# Access Compliance Report

## Public Rights-of-Way

### (Curb Ramps)

Intersection ID: 6621	Main Street: MINERAL_SPRINGS_RD	Cross Street: NEAL_RD	Location: NE
ADA ID: 876964FE0D8E	Ramp Type: Perp	Initial Pass/Fail: Fail	Overall Compliance: No
			Severity Score: 21.25

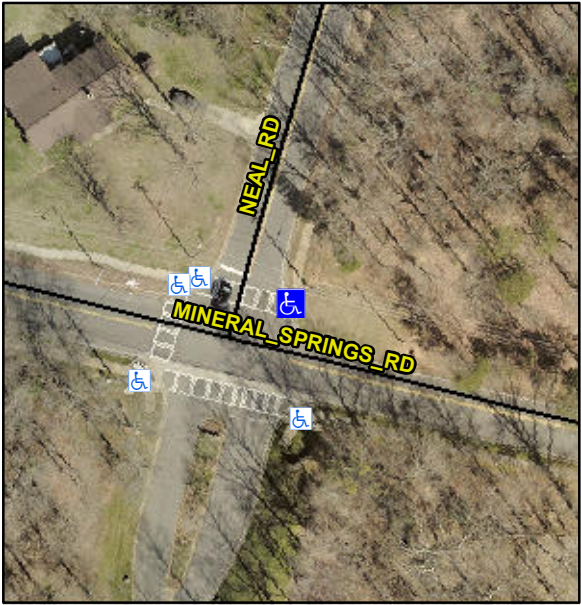
Codes/Mitigation Info/Possible Solution			Field Measurements/Component Compliance		
	Possible Solutions:		<b>Compliance</b>	<b>Description</b>	<b>Data</b>
	<b>Remove &amp; Replace Entire Ramp.</b>		<b>No</b>	Ramp Length (in)	48.0
			<b>No</b>	Ramp Width (in)	43.0
			<b>N/A</b>	Flare Type LT	N/A
			<b>N/A</b>	Flare Slope LT (%)	N/A
			<b>N/A</b>	Flare Traversable LT?	N/A
			<b>N/A</b>	Landing Length (in)	N/A
			<b>N/A</b>	Landing Width (in)	N/A
			<b>N/A</b>	Landing Slope (%)	N/A
			<b>N/A</b>	Landing X Slope (%)	N/A
<p>Surveyor Notes:</p> <p><b>N/A</b></p> <p>PROW/ADA:</p> <p><b>Not Found, R304.5.1, R304.2.2</b></p>			<b>N/A</b>	Flare Type RT	N/A
			<b>N/A</b>	Flare Slope RT (%)	N/A
			<b>N/A</b>	Flare Traversable RT?	N/A
			<b>N/A</b>	DWS Provided?	N/A
			<b>N/A</b>	DWS Contrast?	N/A
			<b>N/A</b>	DWS Length (in)	N/A
			<b>N/A</b>	DWS Full Width?	N/A
			<b>N/A</b>	DWS Offset (in)	N/A
			<b>N/A</b>	Shared Landing?	N/A
